IFB No. 20-61 Cherry Valley School North Parking Lot Reconstruction

RE: ADDENDUM NO. 1

ADDENDUM NO. 1

TO THE BID SET AND SPECIFICATIONS FOR Rockford Public Schools - IFB NO. 20-61 North Parking Lot Cherry Valley Elementary School Pre-Bid Date: June 2, 2020

1. Sheet 4 - Removal Plan

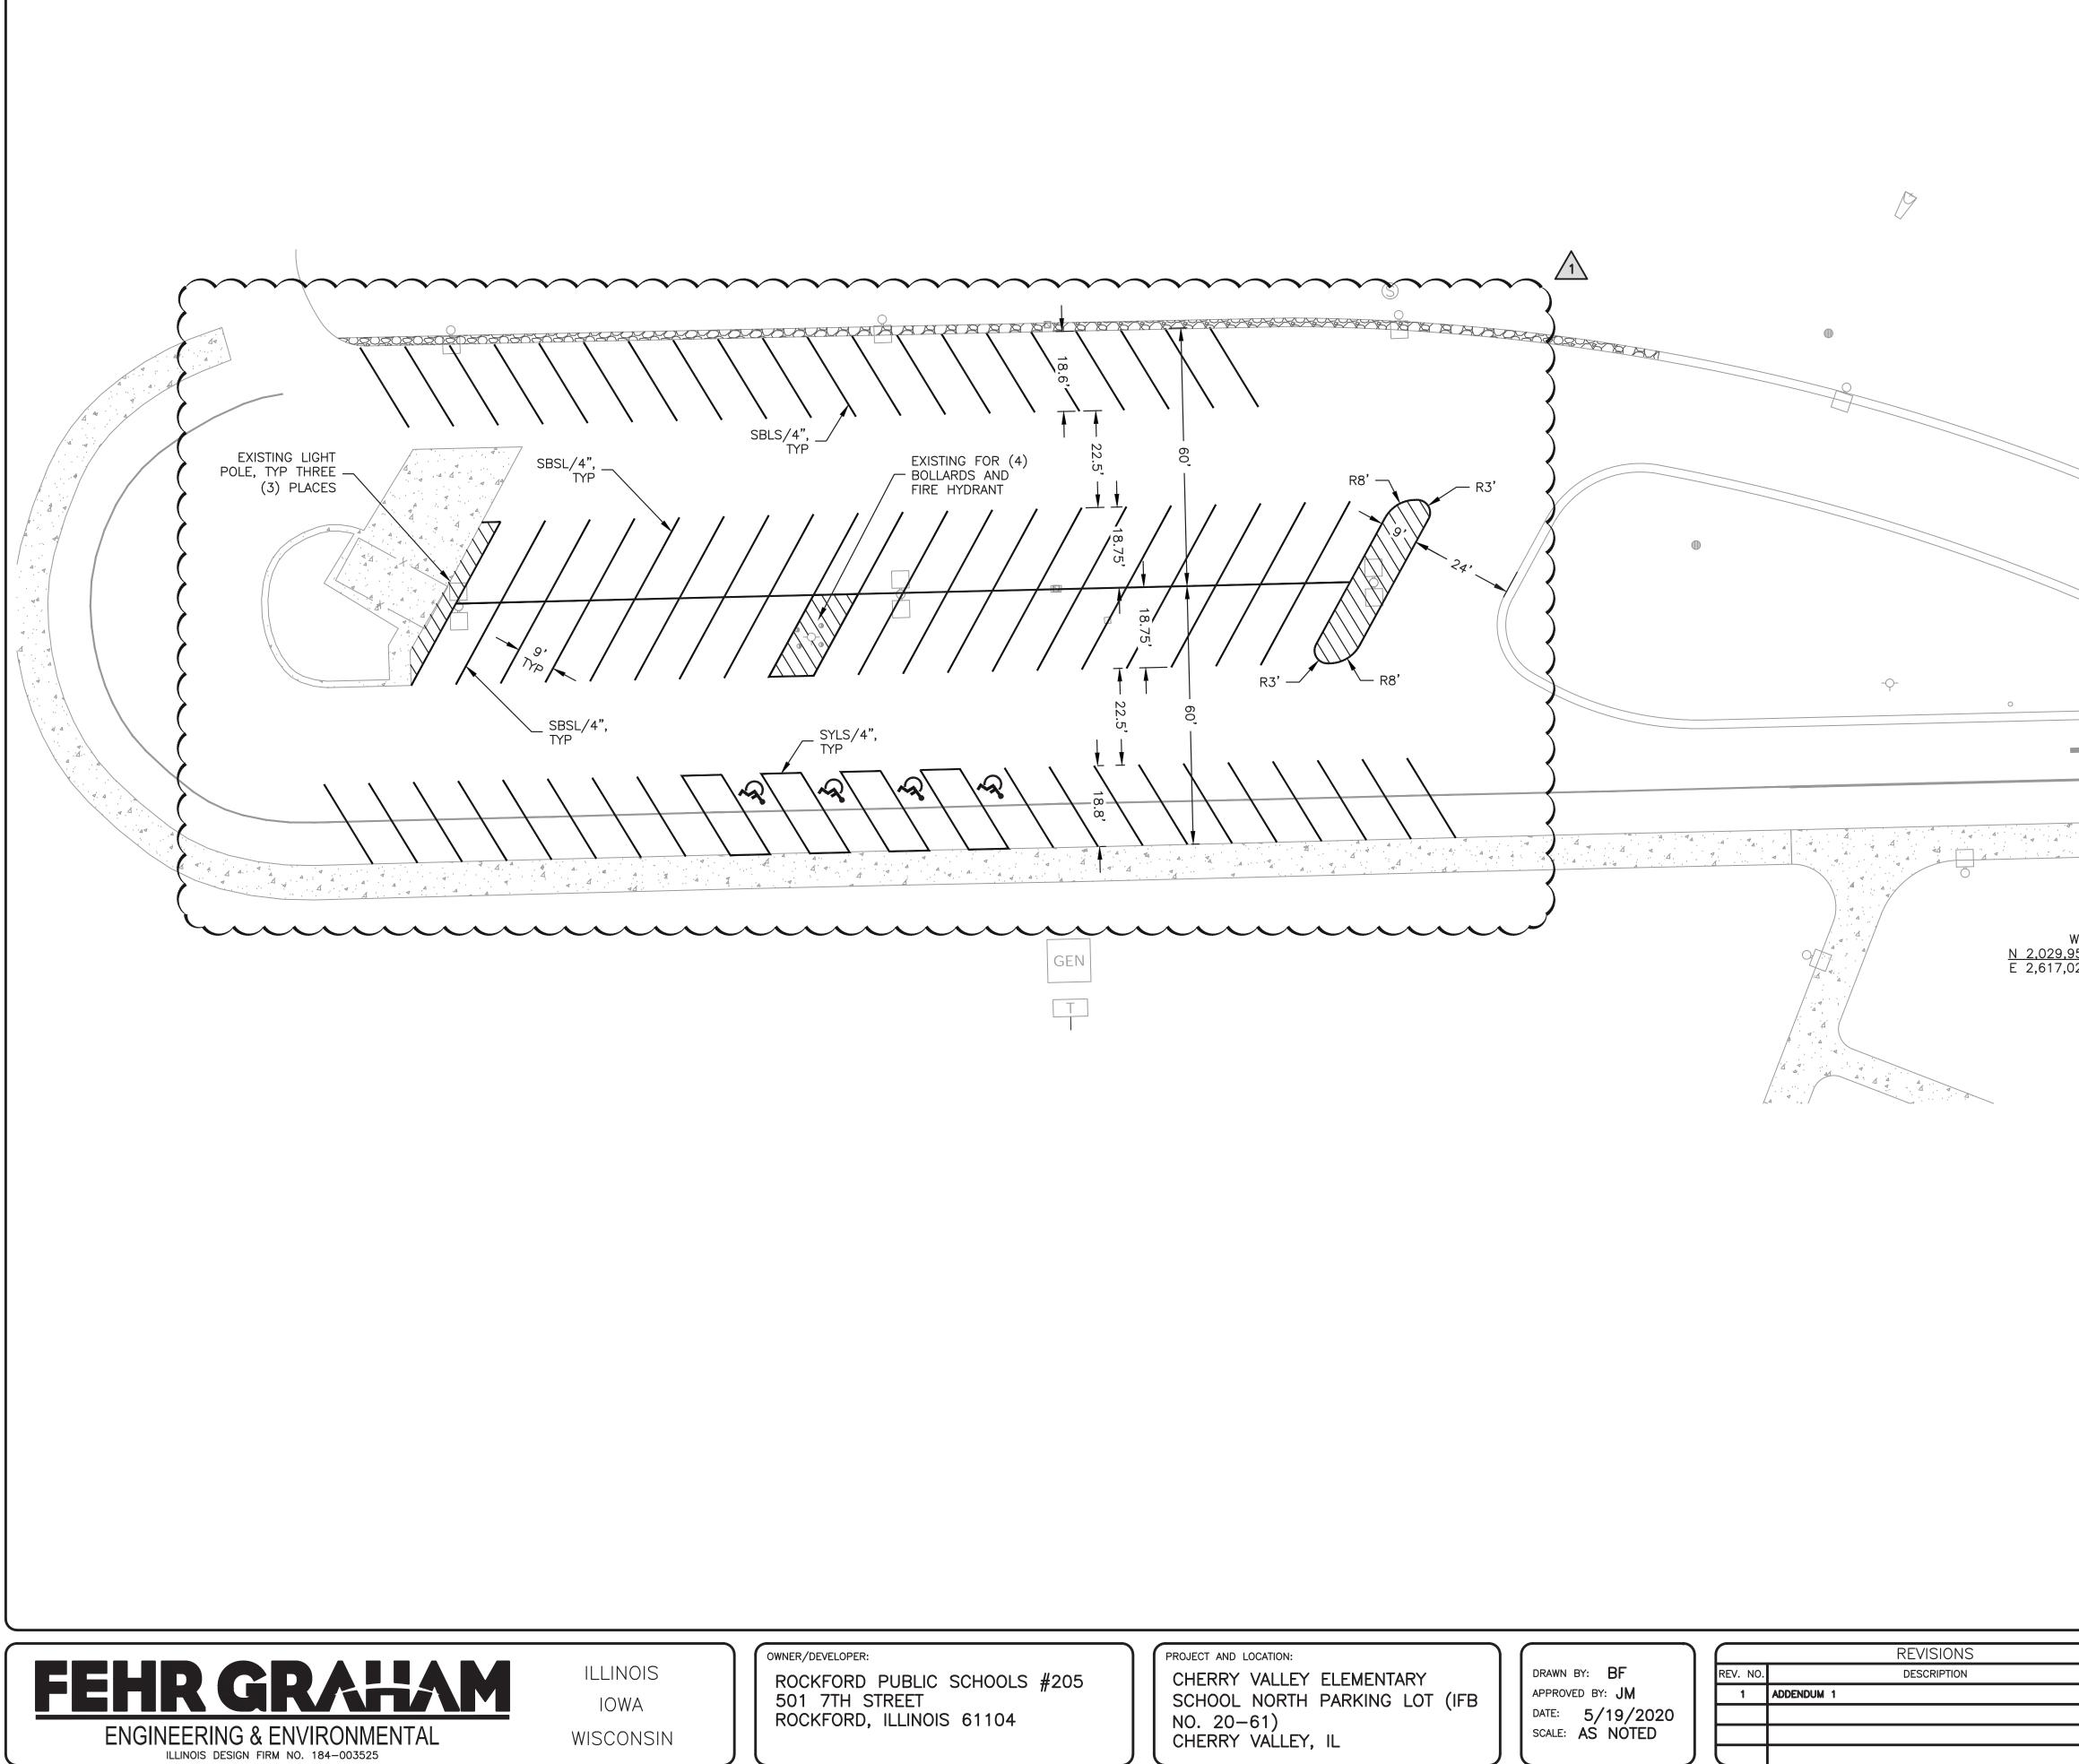
- A. The 4 bollards around the fire hydrant in parking lot are to be removed and replaced in same position during construction.
- B. Added General Note Existing underground electrical wires need to be protected and if disturbed replaced by contractor at no additional cost

EXISTING UNDERGROUND ELECTRICAL WIRES NEED TO BE PROTECTED AND IF DISTURBED REPLACED BY CONTRACTOR AT NO ADDITIONAL COST.

2. <u>Sheet 6 - Striping Plan</u>

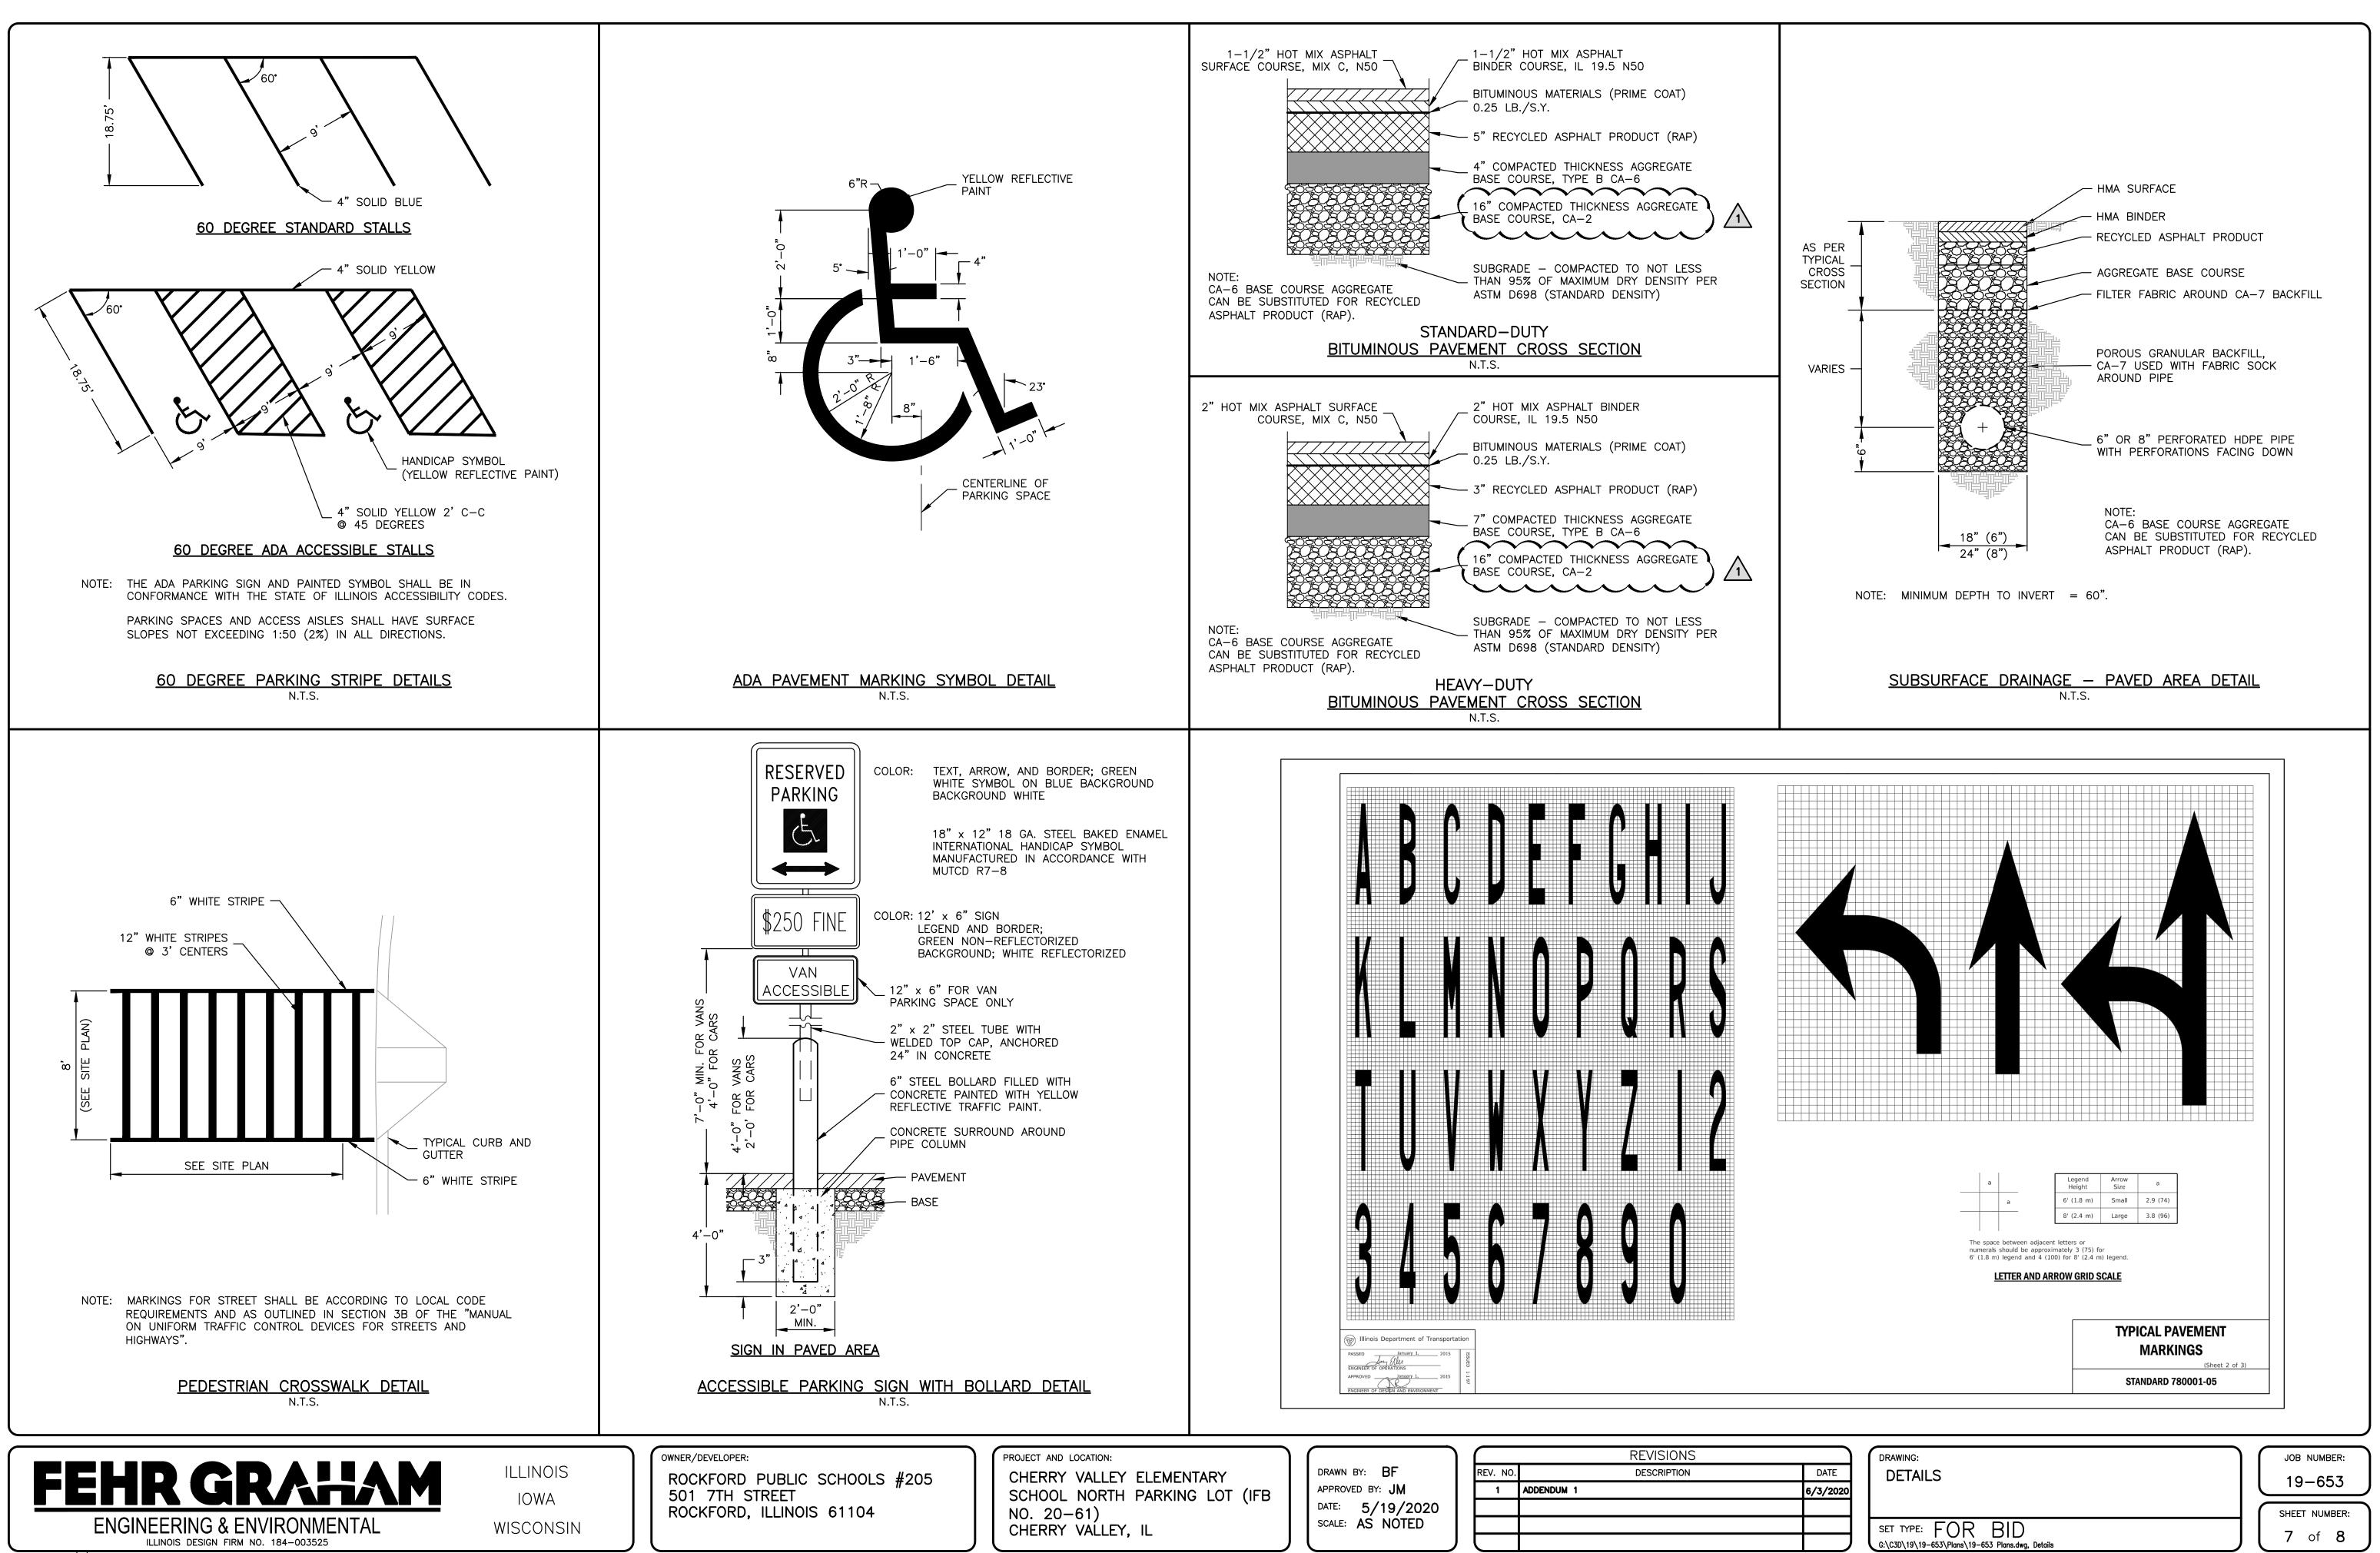
A. Striping plan has been revised and now includes both SBLS - 4" and SYLS - 4" pavement markings
